COLLINS RADIO COMPANY

REVISION NO. 1
TO
PM-2 SERVICE BULLETIN NO. 1

COMMUNICATIONS
PM-2 LIGHTWEIGHT AC POWER SUPPLY FOR KWM-2/2A TRANSCEIVER
SERVICE BULLETIN NO. 1
EXTENSION OF DESIGN SPECIFICATIONS FOR INPUT VOLTAGE LIMITS

PM-2 Chassis Frame With TB1 Removed, Partial Bottom View
Figure 1

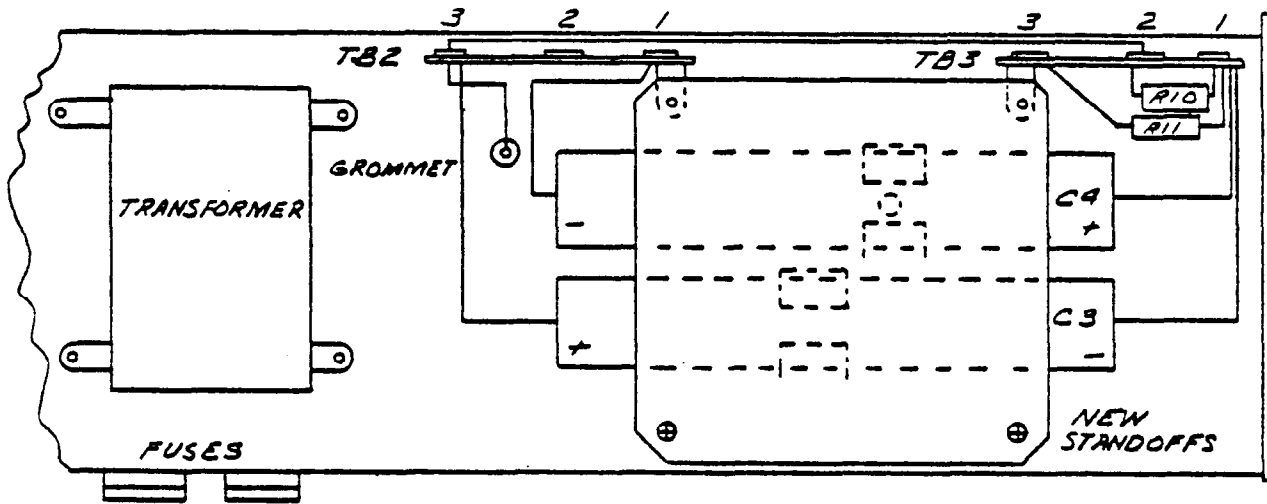
4. Drill the three holes in chassis as shown in figure 1.
5. Fasten the four clips (139-3171-00) in place with two machine screws (343-0132-00) and nuts (313-0043-00) as shown in figures 2 and 3. Insert the screws in the two smaller new holes with a clip on each side of the chassis.

PM-2, Partial Top View
Figure 2

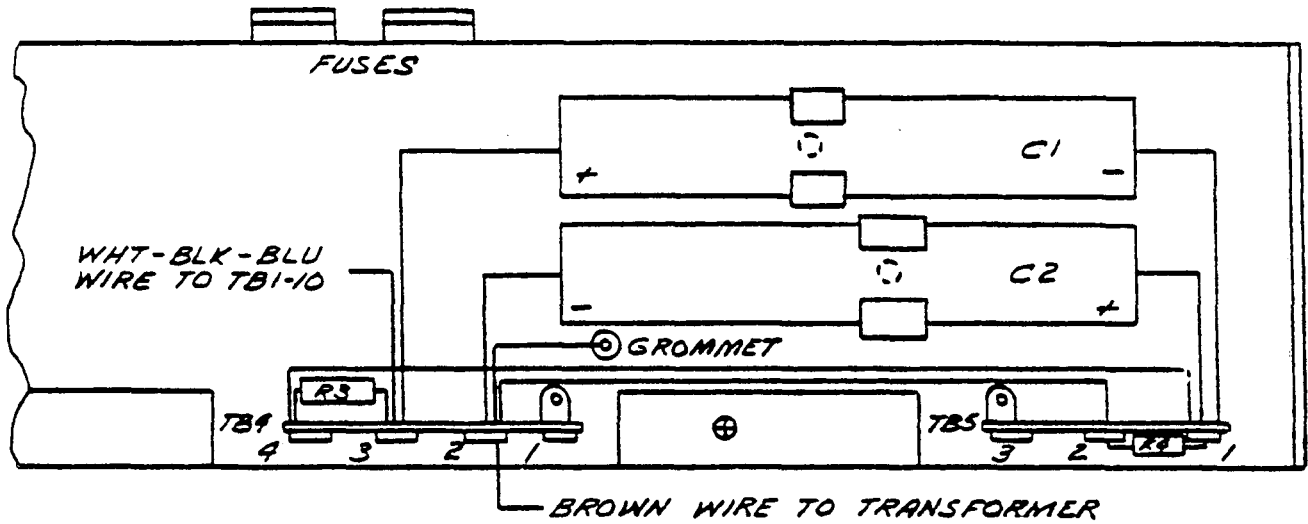
13. Add 270K resistors R3, R4, R10, R11 (745-3454-00) as shown in figures 2 and 3.
14. Remove and discard 20-uf capacitors C1, C2, C3, and C4 located on back side of terminal board TB1.

23. Sleeve with insulation (152-1351-00) the leads of the four newly installed capacitors and connect as shown in figures 2 and 3. CHECK POLARITY MARKINGS.

PM-2 With TB1 in Place, Partial Bottom View
Figure 3

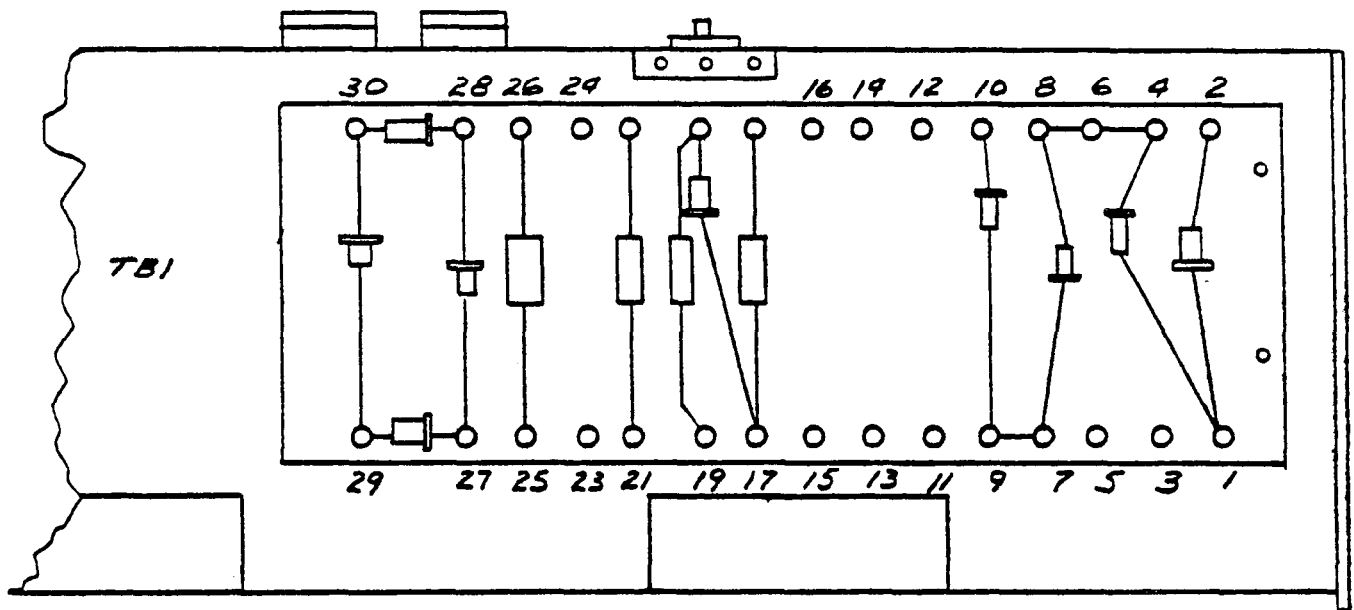
6. Insert rubber grommet (201-1040-00) in the larger of the three newly drilled holes.
7. Add 4-lug terminal strip TB4 (306-0698-00) on the bottom side of the chassis securing with rear mounting screw of transformer T1 that is nearest speaker. See figure 3. The hole in the mounting tab may have to be enlarged slightly to allow insertion of the mounting screw.

8. Add 3-lug terminal strip TB5 (306-0587-00) on the bottom side of the chassis securing with front mounting screw of speaker that is nearest outside of chassis. See figure 3.

19. Disconnect brown wire from terminal 5 on TB1 and connect to terminal 2 of TB4. See figures 3, 4, and 5.
20. Add white-black-blue wire (439-1810-00) from terminal 10 on TB1 to terminal 3 of TB4.

PM-2 With TB1 in Place, Partial Bottom View
Figure 4

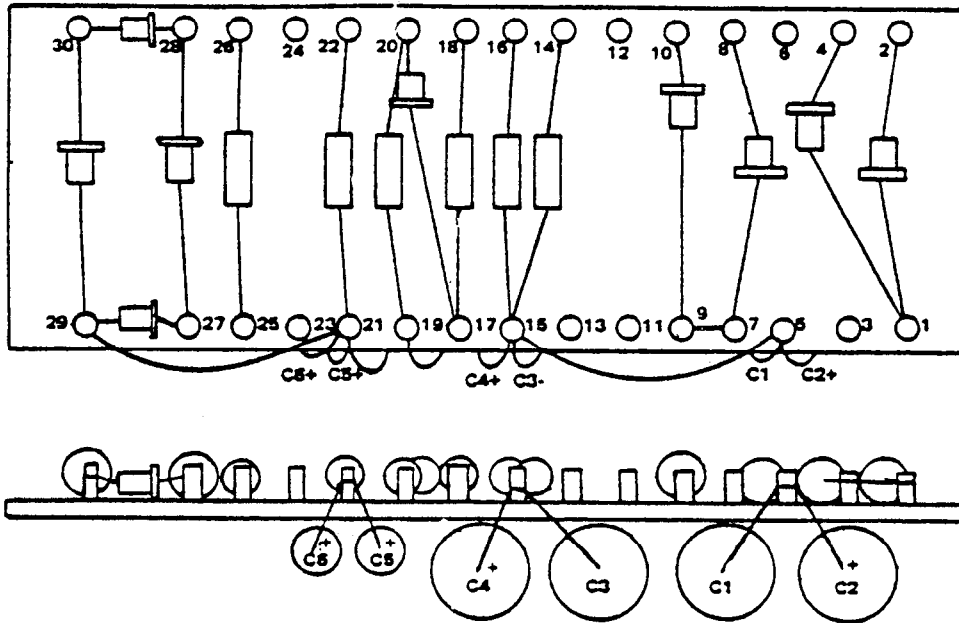
15. Remove and discard old 470K resistors R3 and R4 located on front side of terminal board TB1.
16. Remove bus wire connected between terminals 10 and 14 on TB1. See figures 4 and 5 for TB1 terminal designations.

PM-2 TB1 Partial Bottom and Edge View
Figure 5

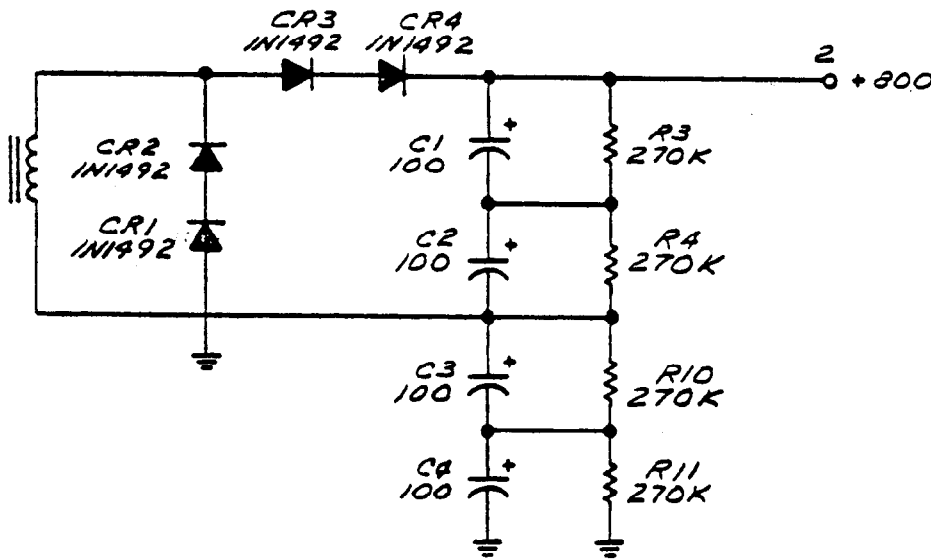
1. To change to a slightly longer standoff post than the one listed in the original modification kit.
2. To add a reference to the new edition of the PM-2 instruction sheet.
3. Add new illustration (figure 5, original figure 5 is changed to figure 6).
